File: Town of Tonawanda Landfill
EnSol P/N 99-0025

Re: FUSRAP Limits Evaluation

Date: January 21, 2008
To: [REDACTED], P.E.
[REDACTED], P.E.
From: [REDACTED], LSIT
Re: Tonawanda Landfill - FUSRAP Limits Evaluation

FIGURE
2

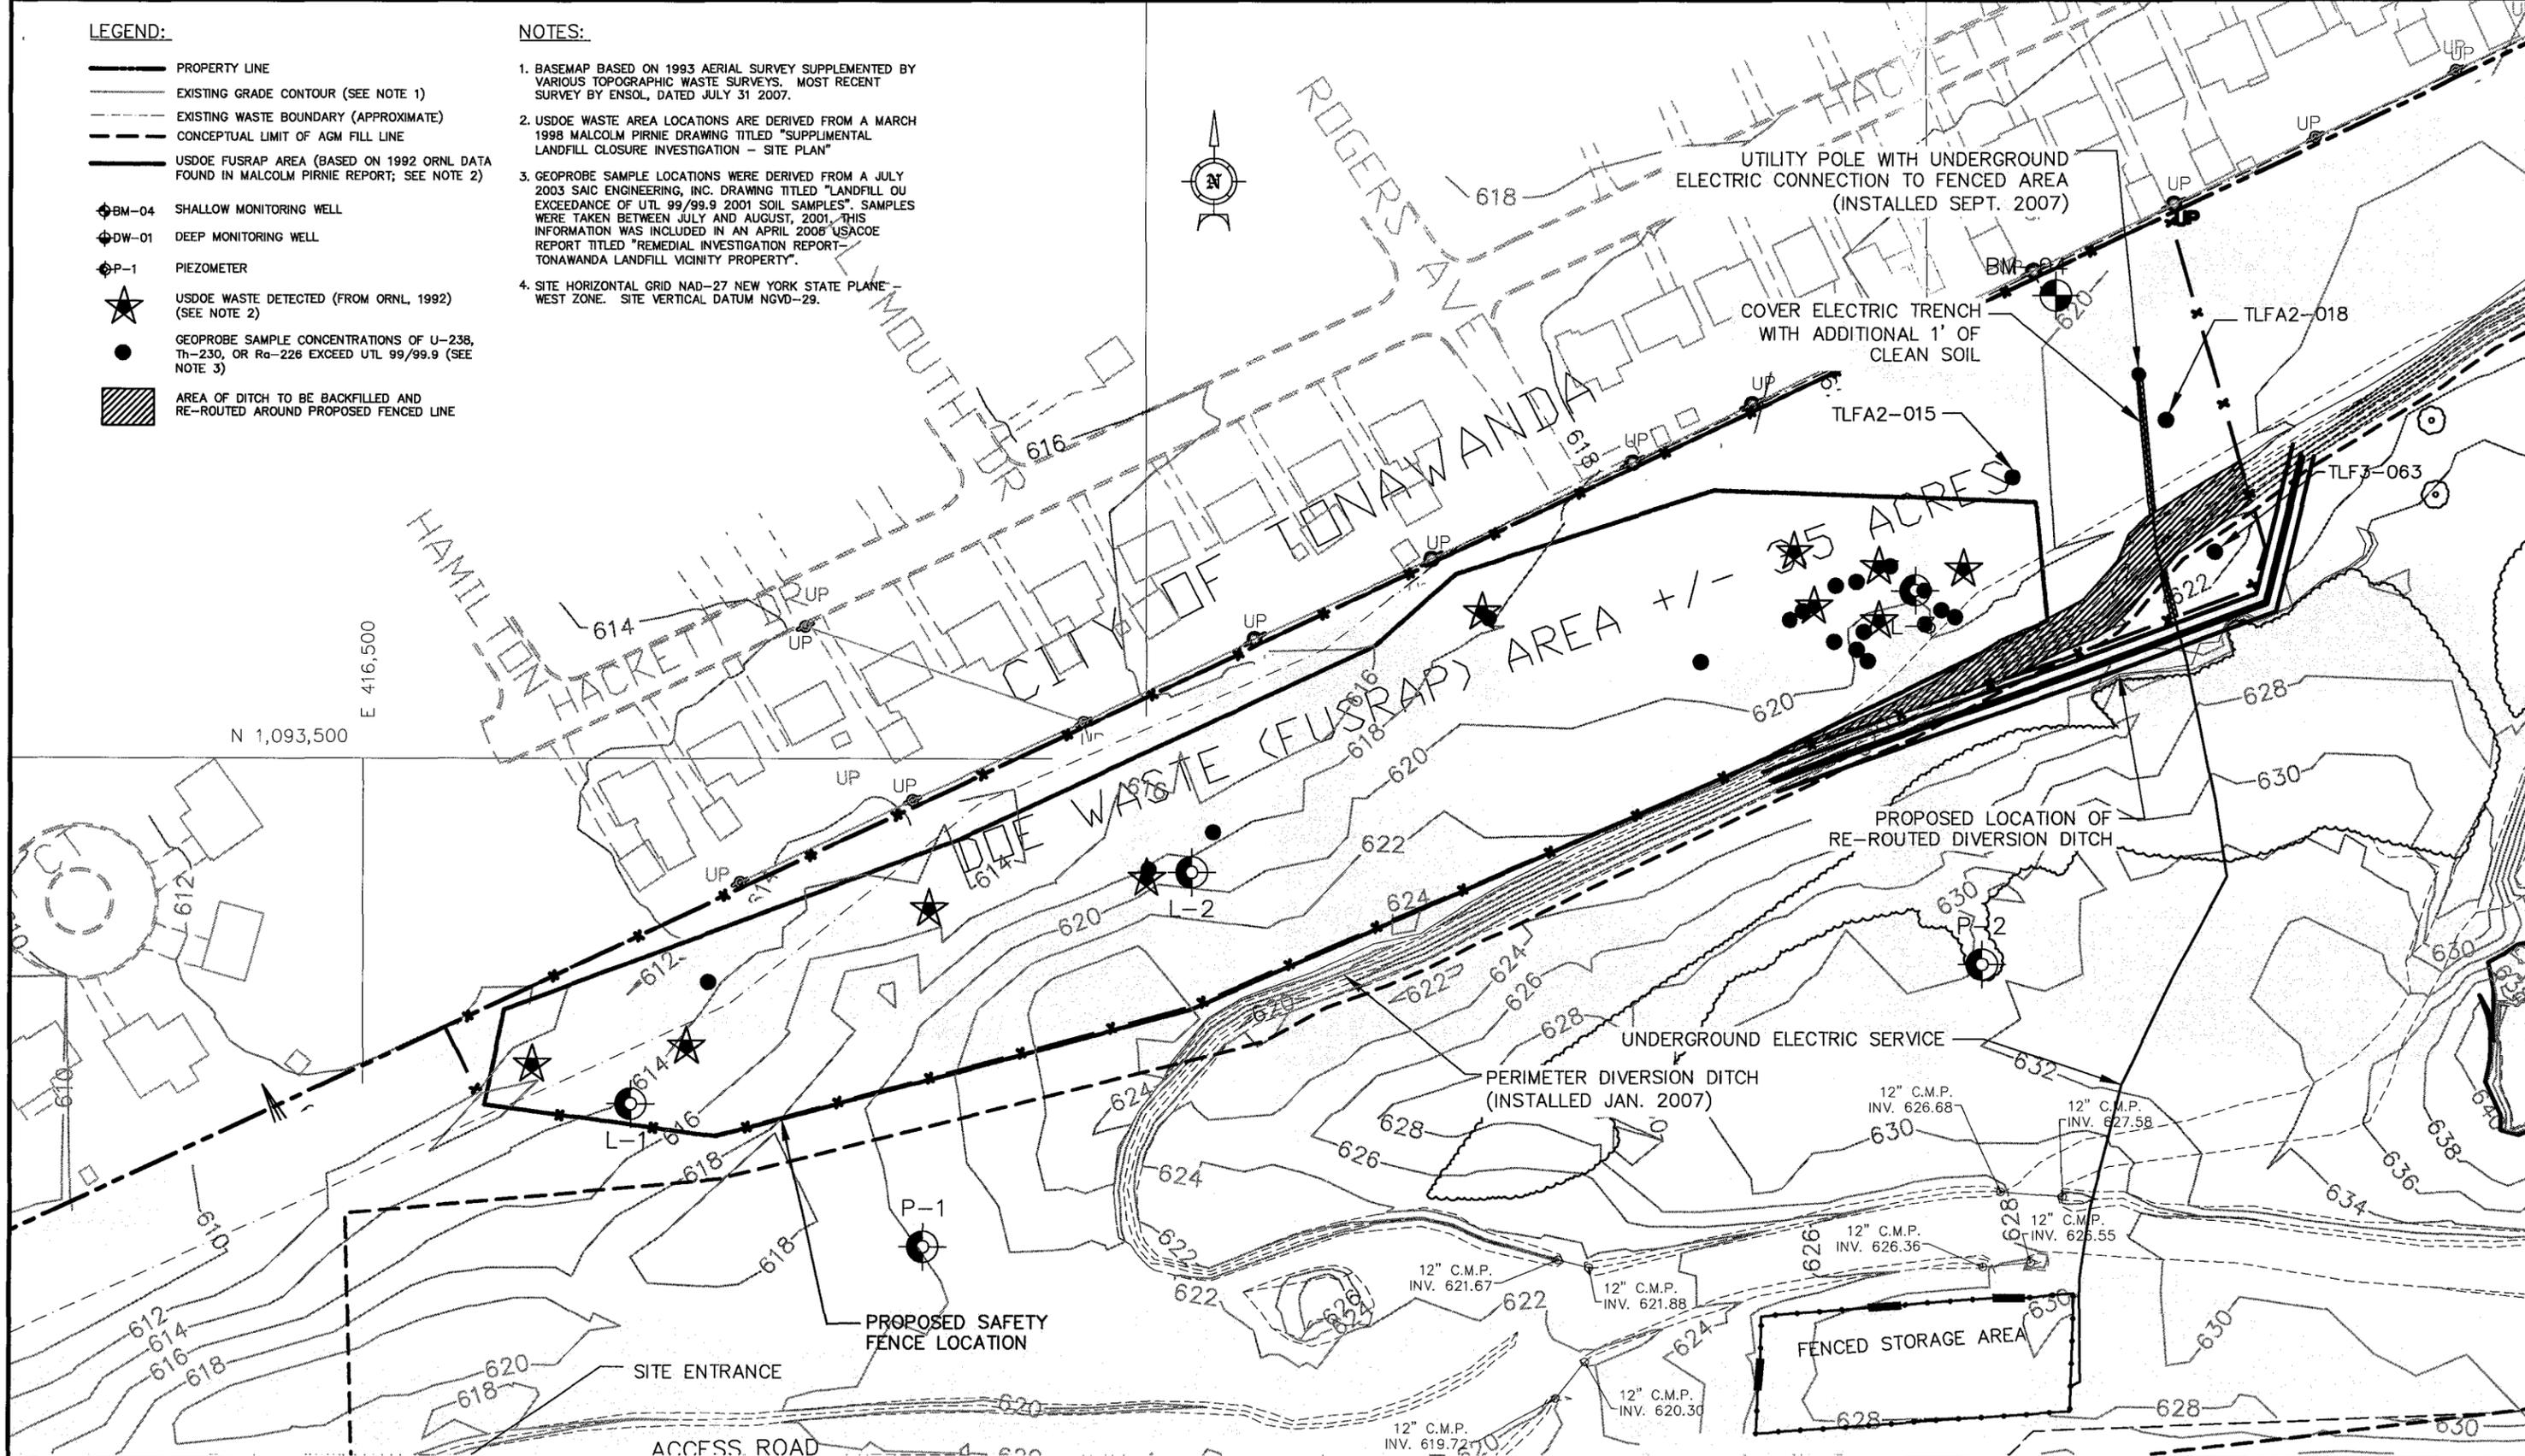
three locations identified as part of the 2001 FUSRAP investigation that fall outside of the previously established FUSRAP boundary are in the vicinity of the recent construction activities. More specifically, the two sample locations are labeled "TLFA2-018" and "TLF3-063" on Figure 4-11 of the April 2005 USACOE Report (also shown on the figures provided).

- According to the 2005 USACOE Report, the depth at which the elevated levels (above screening Level UTL 99/99.9) were found for the above mentioned sample locations are as follows:
 1. TLFA2-018 (near electric line trench) - 3.5 feet below ground surface.
 2. TLF3-063 (near Western diversion swale) - 2.5 feet below ground surface.
- The depth of disturbance for the recent construction activities are as follows:
 1. The utility pole was set in a 6-foot deep augured hole.
 2. The trench containing the electric line was installed approximately 3 feet deep.
 3. The diversion ditch is approximately 2.5 feet below pre-construction grades in the area of sample location TLF3-063.
- The FUSRAP boundary was not revised based on the additional 2001 data included in the USACOE 2005 Report.

1. The FUSRAP boundary will be revised and field delineated using engineering controls including safety fence and signs (see attached figures). This action will inhibit unauthorized access to the newly established FUSRAP area.
2. The area of diversion ditch within the safety fence line will be backfilled with the adjacent excavated soils and covered with an additional 1-foot minimum of clean soil and re-routed around the fence line (see attached figures).
3. An additional 1-foot minimum of clean soil will be placed over the electric line trench located within the revised FUSRAP boundary.
